AEOD/E010

SUBJECT: TIE BREAKER BETWEEN REDUNDANT CLASS 1E BUSES -  
POINT BEACH NUCLEAR PLANT, UNITS 1 AND 2

DOCKET NO. 50-301  
POINT BEACH NUCLEAR PLANT UNIT 2  
LICENSEE EVENT REPORT NO. 80-005/03L-0

SIMPLIFIED ELECTRICAL ONE LINE DIAGRAM...  
 POINT BEACH NUCLEAR PLANT  
 UNITS 1 & 2

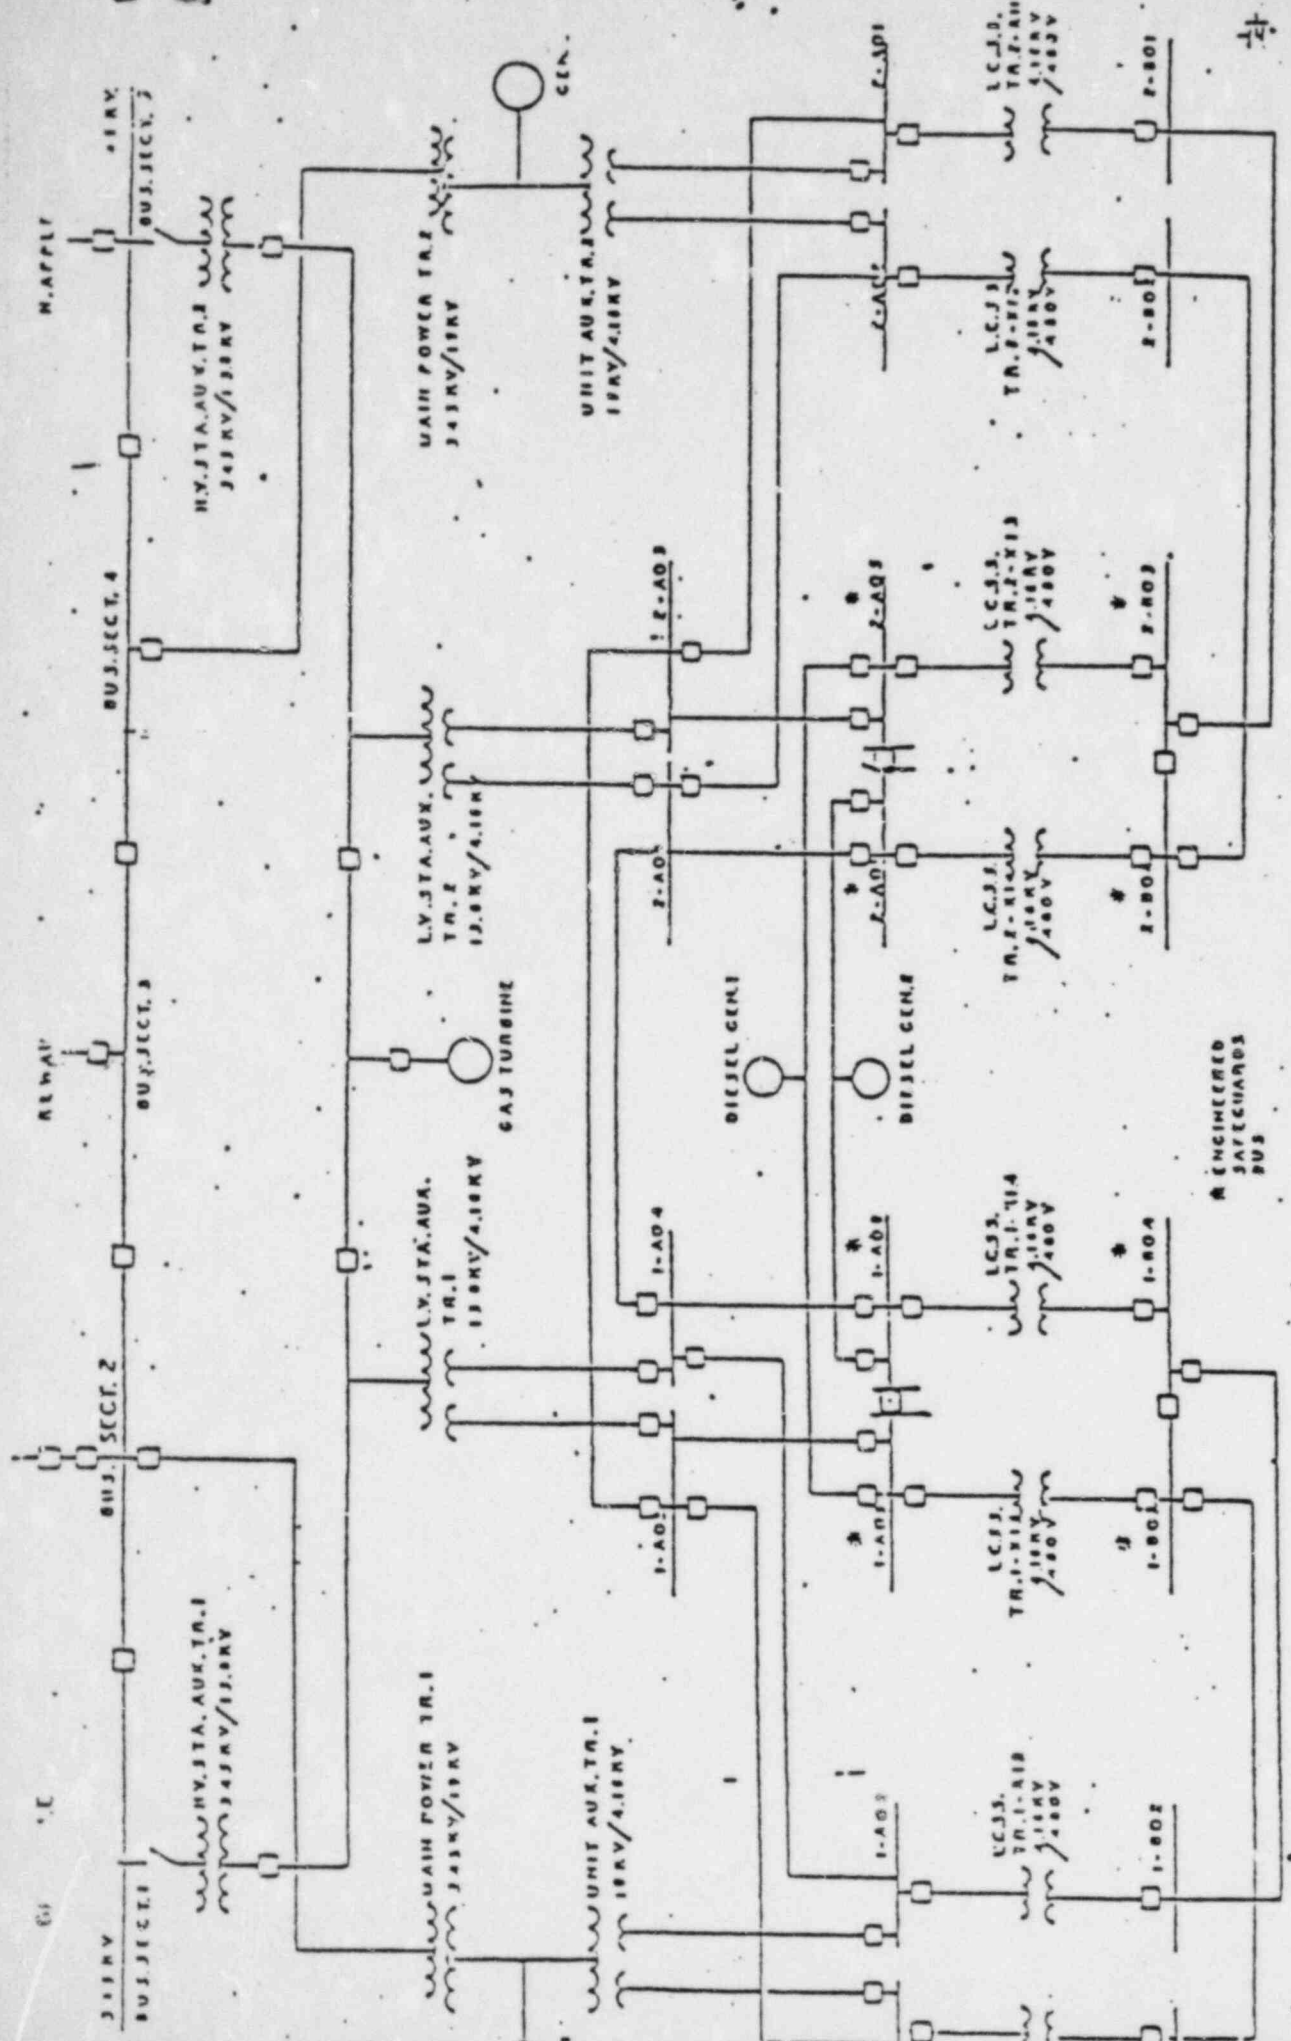
Each unit of Point Beach Nuclear Plant has tie breakers that interconnect redundant Class 1E buses; one between 4160V Class 1E buses and another between 480V Class 1E buses (see enclosed one line diagram). The tie breakers had been provided for flexibility in operation of the distribution system. They are designed to automatically open (when closed) upon loss of normal ac power supply to the buses. The control scheme of a tie breaker is such that it cannot be closed when both the normal feeder breakers to the buses are closed. Interlocks are provided that will prevent closure of a normal feeder breaker if the tie breaker is closed. Interlocks are also provided between the emergency diesel generator output breakers and the 4160V tie breaker that will prevent closure of the diesel generator breaker if the tie breaker is closed. All these design features insure that redundant power sources are not operated in parallel when redundant load groups are interconnected. However, the plant design does not prevent the closure of the 4160V tie breaker when the 4160V Class 1E buses are supplied power by the emergency diesel generators. This is contrary to the requirements of Position 4(d) of

Regulatory Guide 1.6,\* which states that if manual connection of redundant load groups is possible, then at least one interlock should be provided to prevent parallel operation of standby power sources.

We believe that the design of the interconnection between redundant safety-related electrical load groups at Point Beach Nuclear Power Plant, Units 1 and 2, should be reviewed and modified, as required, to assure that it fully complies with the requirements of Regulatory Guide 1.6.

To prevent future recurrence of this event, the electrical layout board will be modified to provide unique identification of the A05 and A06 buses' tie breaker. This modification will also include like tie breakers between other safeguards buses. Also, procedures will be changed to include an electrical lineup check after performance of the loss of AC test and prior to return to power.
